**PARKING LOT ADDITIONS & RENOVATIONS
POQUONOCK SCHOOL
WINDSOR, CT**

ADDENDUM NO.3

February 7, 2020

MONOLITHIC CONCRETE CURB AND SIDEWALK

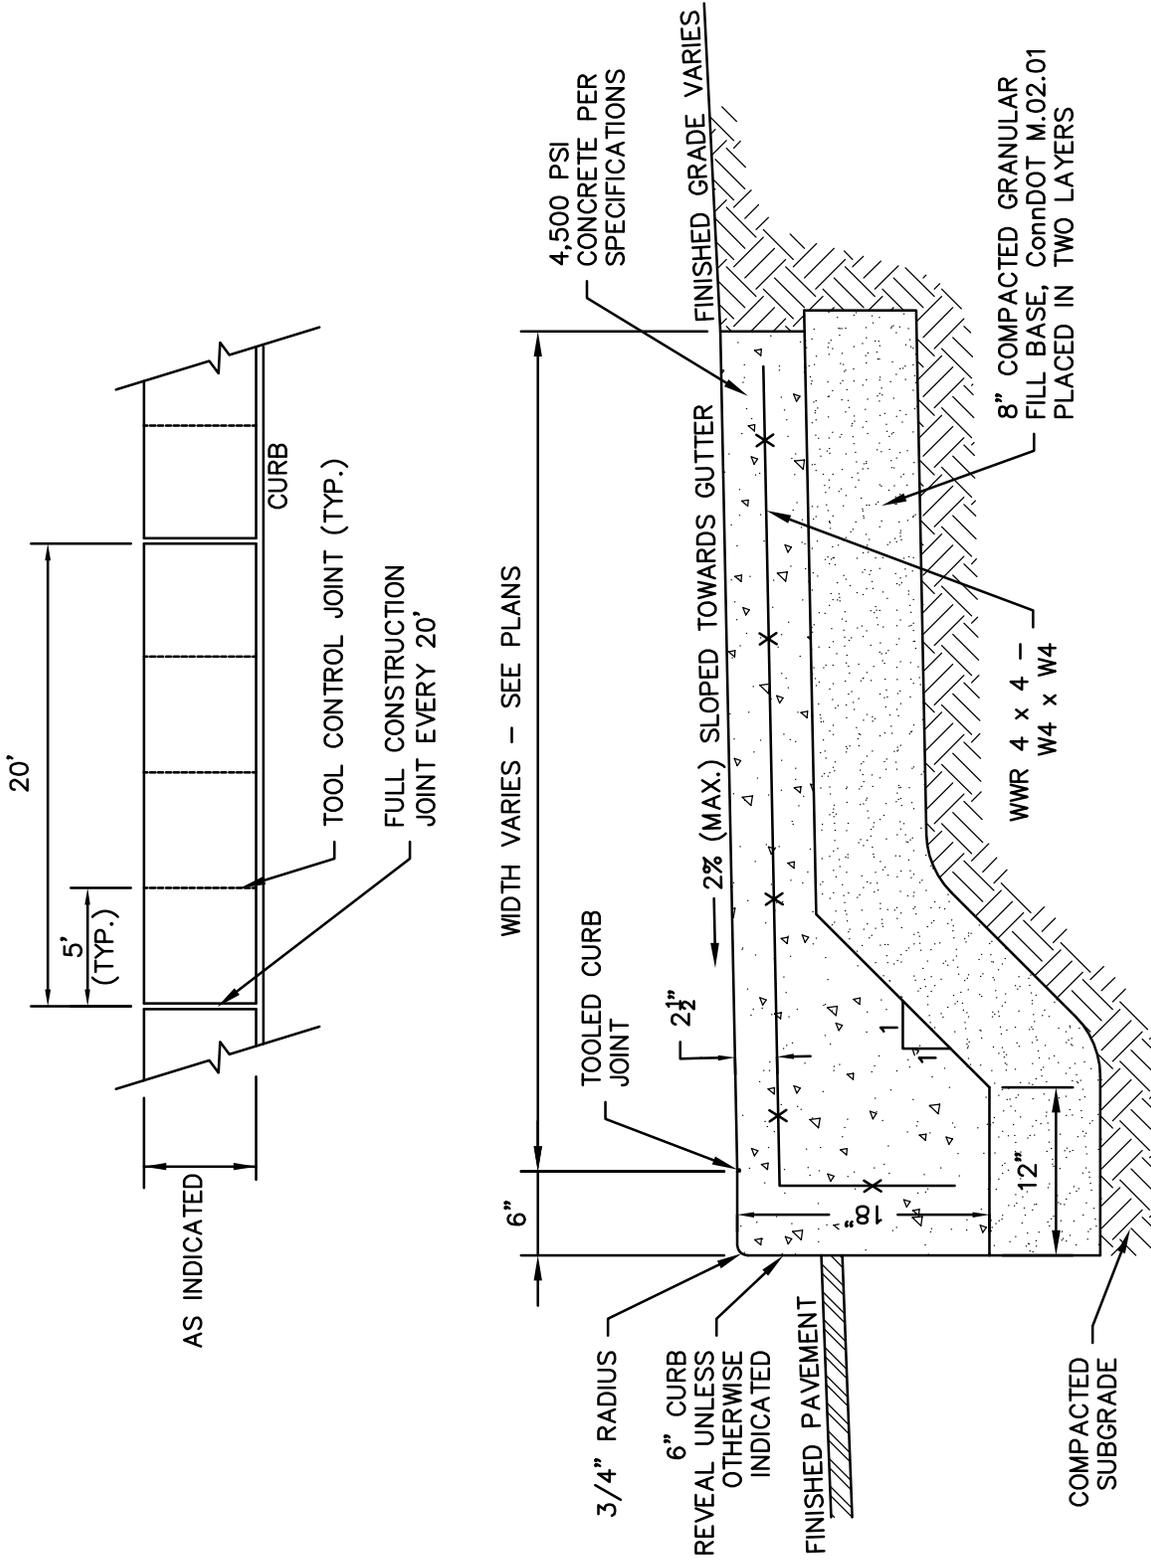
Question 3: MCC Curbing – is there a detail?

Response: See attached Detail for MCC Curbing. Bid plans will not be revised to include this Detail.
